REBUTTAL PROOF OF EVIDENCE ON NOISE DANI FIUMICELLI

SITE AT FORMER B&Q, GREATSTONE ROAD, TRAFFORD, M32 0YP

PLANNING APPEAL

PINS REF: APP/Q4245/W/20/3258552

FIGURE 1: LAeq,15 MIN NOISE LEVELS MEASURED AT THE FOH MIXING DESK AND BOUNDARY SURVEY LOCATION

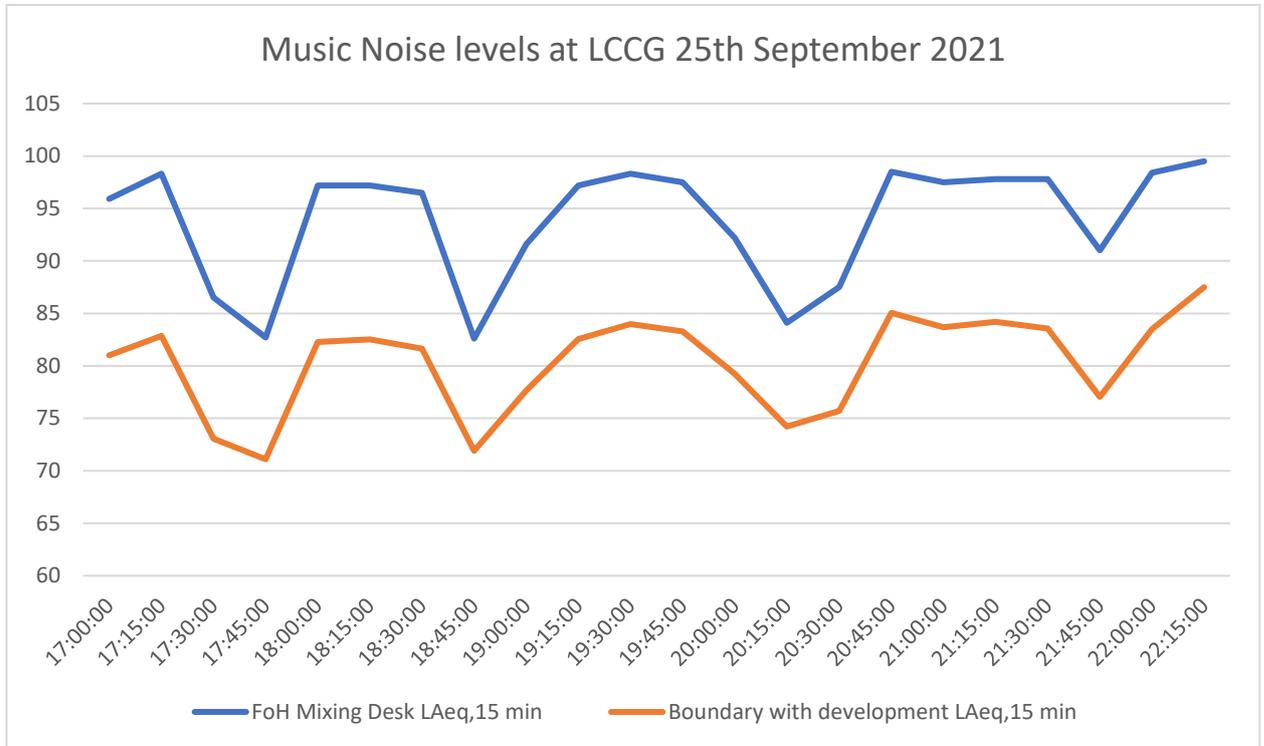
- 2.1. At paragraph 5.23 Mr Patterson writes "*I note that the Vanguardia survey was unattended, so it is not possible to determine whether contributions from other sources may have elevated their readings. In particular, I note that the survey was set up near an access door and ambulance bay.*"

- 2.2. I selected the noise survey position as it was close to the boundary of the development site and in an area closed to the public where there was little pedestrian traffic. The location was near an ambulance bay and access door but there was little if any noise from these sources as there was no need to sound emergency sirens as the access in and out of the LCCG was specifically set up to allow emergency service vehicles to enter and leave if required. Furthermore, sounding sirens would present a risk of triggering panic in the crowd and a risk of "stampede" reactions. The access door was used infrequently by individuals and did not generate significant, if any, noise.

- 2.3. I installed the noise equipment with a colleague and visited each time a new group began performing on stage to observe the initial measurements and verify that levels were dominated by music noise when artists were performing.

- 2.4. The plots in the figure below show that the noise level at the measurement position consistently followed the equivalent simultaneous level at the front of house (FoH) mixing desk in the concert arena. This confirms that at the survey location close to the boundary with the development site music noise dominated over all other potential sources. If noises other than music had significantly influenced the measurements at the survey location, then the pattern of rise and fall of noise levels between the FoH mixing desk and the monitoring location adjacent to the development site would not have been so closely matched.
